Subject: **UNRECOGNIZABLE SERIAL DIGITAL (D-1) AUTO SETUP FROM REMOTE CONTROL MODE**

Model: **BKM-2085-14, BKM-2085-20, BVM-1316C**

Figure 1

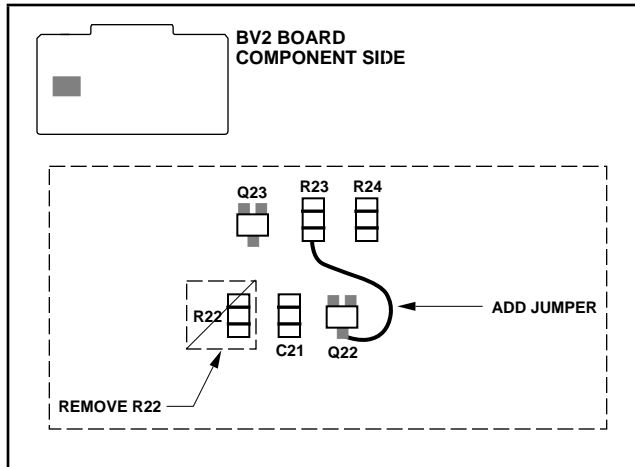
When serial digital (D-1) input is selected using remote control mode, the RGB/COMPONENT menu is displayed instead of the serial digital (D-1) Auto Setup menu. To correct this condition, perform the following modification procedure.

BV2 Board (Component Side)
 (See Figures 1 and 2.)

1. Remove R22.
2. Solder jumper between R23 and Q22 collector.
